Access Compliance Report

Public Rights-of-Way

(Curb Ramps)

Intersection ID: 31209	Main Street: CAPRINGTON_AV	Cross Street: CLACKWYCK_LN	Location: S
ADA ID: D5FCB7E69F57	Ramp Type: PerpDiag	Initial Pass/Fail: Fail	Overall Compliance: No
		Severity Score: 25

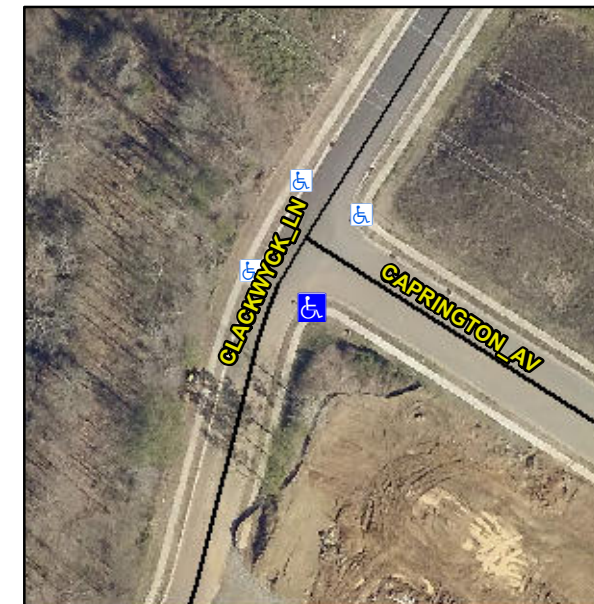
Not Found, R304.5.3

Remove & Replace Curb Ramp With Two New Directional Ramps or Equivalent.
